ZR750-C1/L Kawasaki CYLINDER HEAD COVER GASKET		MC90-07 November 16, 1990
---	--	---	------------------------------

FACTORY DIRECTED MODIFICATION

Repair Procedure

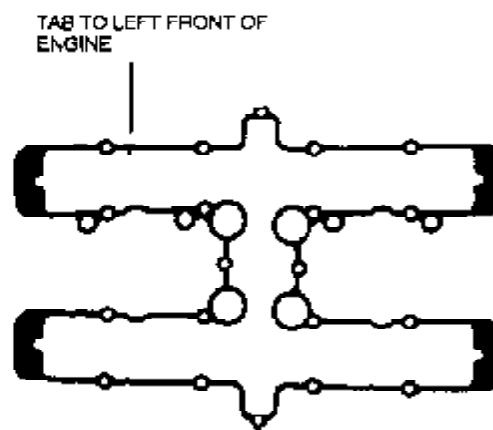
The cylinder head cover gasket may leak oil after about 600 miles of use.

The material of the cylinder head cover gasket has been changed to stand up better to high temperatures.

- Remove the fuel tank.
- Pull off the sparkplug connectors, and remove the ignition coils.
- Disconnect the air suction system hoses from the cylinder head cover.
- Take out the 24 bolts holding down the cylinder head cover, and remove it.
- Peel off the gasket and the four plugs and discard them.
- Clean the sealing surfaces of the head and cover thoroughly. Be sure to remove all traces of old sealant.
- Put silicone sealant (Kawasaki Bond, P/N 56018-120 or equivalent) on all the sealing surfaces of the new cover plugs.
- Install the new cover gasket, with the small tab on the left front.
- Put the cover in place, apply a non-permanent locking agent (LOCTITE Lock n' Seal, P/N K61079-001, or equivalent) to the threads of the four Allen head bolts, and screw them into the four ends of the cover.

- Put in the 20 hex head bolts, and tighten all 24 bolts to the specified torque.
- Replace the other parts removed.
